Project No: 22-03012

**RE: Lot Line Change Plan Review
1206 Crespo Lane
TMP # 02-019-197
Bensalem Township, Bucks County, PA
Project No. BTSO.00230**

The following is a point-by-point response (shown in Bold) to TPD's review letter dated November 18th, 2022

STORMWATER MANAGEMENT CALCULATIONS:

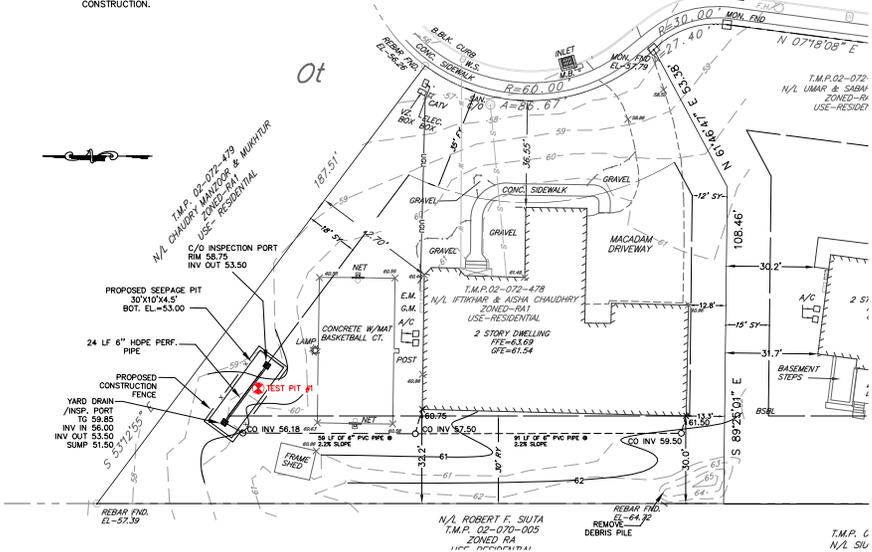
- a) The total impervious surface of the proposed conditions is greater than 5,000 square feet therefore the project is not exempt from peak rate control requirements, or volume control requirements and shall provide a stormwater management (SWM) site plan.

Response: Through conversations with the township engineer the project only increases the impervious surface by 1,716 sf. This calculation is shown on sheet 2 of 5. Additionally the stormwater management system was sized to include the existing basketball court as well.

LOT LINE CHANGE PLAN

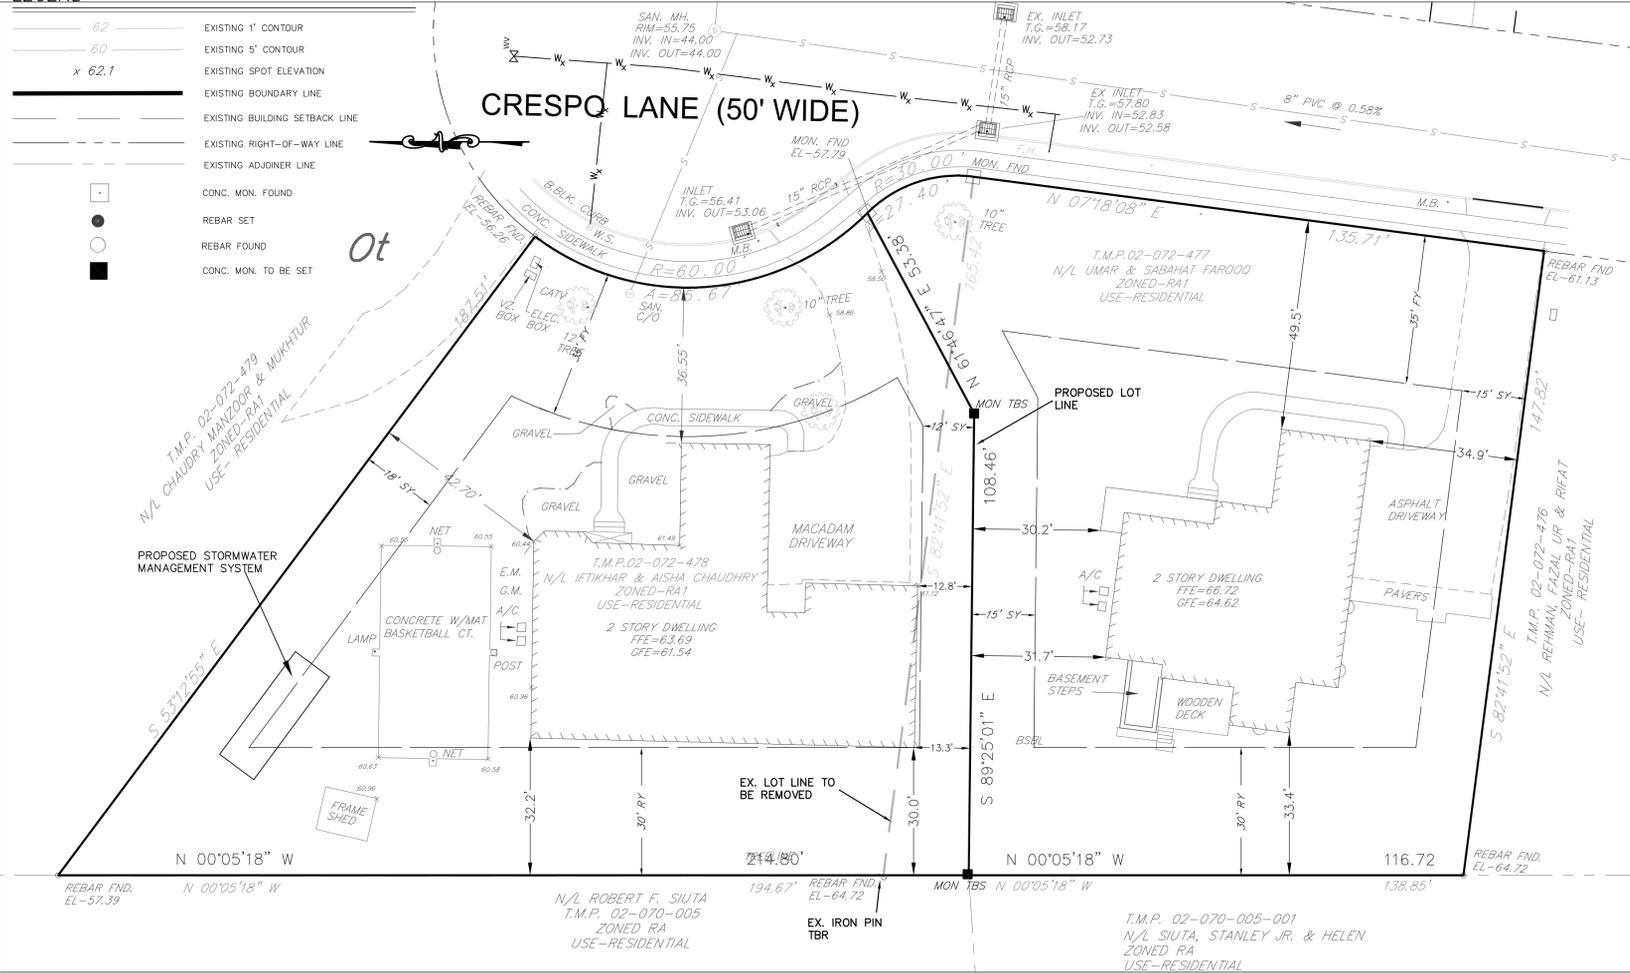
3. The 2nd Stormwater Management certification statement on sheet 1 should be removed as a similar note is to be added to the SWM Site Plan.

Response: This signature block has been removed and the new signature block has been added to the site plan.
